AIR BAG WARNING LAMP, CC MESSAGE 'RESTRAINT SYSTEM'

This Service Information bulletin replaces SI M65 01 17 dated **February 2017**

Seat Control Module Grounding Improvement

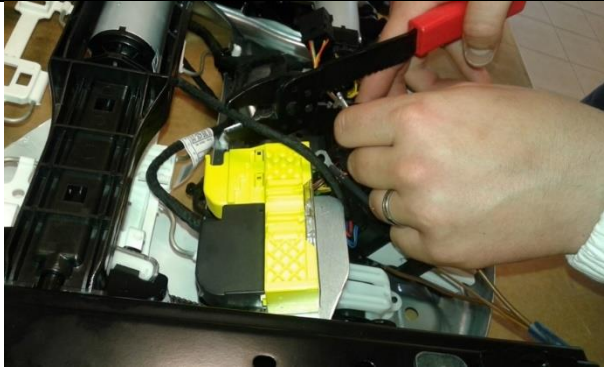
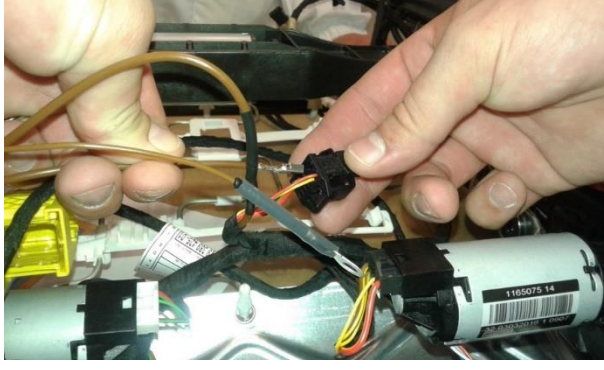
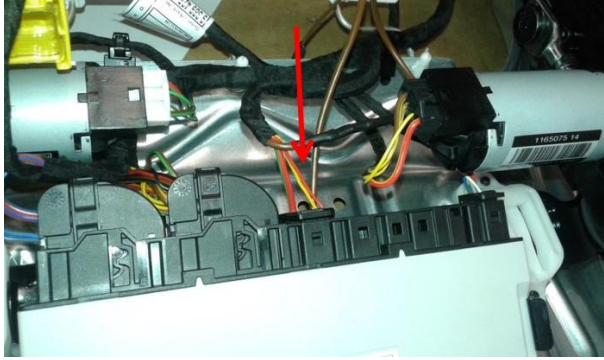
<p>3. Remove connector A245*3B from the seat module.</p>
	<p>4. Open connector and pull out brown ground cable, pin 8.</p>
	<p>5. Cut off the plug.</p>

<p>6. Remove insulation from end of wire.</p>
	<p>7. Ground cable (Part# 61 12 7 492 553)</p> <ul style="list-style-type: none">-Female terminal plugs into module-Ring terminal will be riveted to seat frame-Center wire will be spliced to vehicle harness
	<p>8. Slip shrink tubing (Part# 61 13 1 379 833) over wire of ground cable (Part# 61 12 7 492 553) containing crimp connector (as shown).</p>

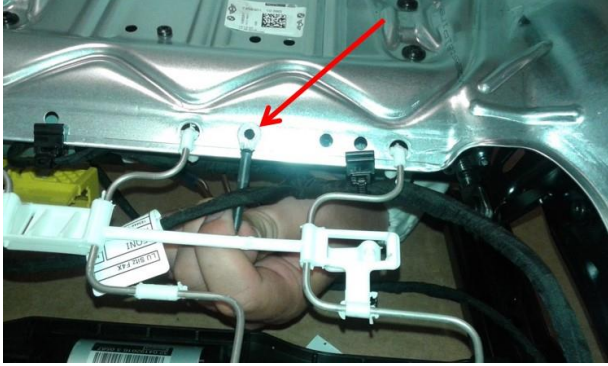
<p>9. Crimp wire, from Step 6 above, into crimp connector.</p>
	<p>10. Reposition shrink tube over connection and heat.</p>
	<p>11. Place wire with cable shoe (on Ground cable) into pin 8 on connector A245*3B.</p>
	<p>12. Reconnect plug to seat control module</p>

<p>13. Drill 5.0mm hole into seat pan where shown</p>
	<p>14. Attach eyelet wire from Ground cable at drilled hole with (4.8mm X 9mm) rivet (part# 07 14 7 444 158).</p>
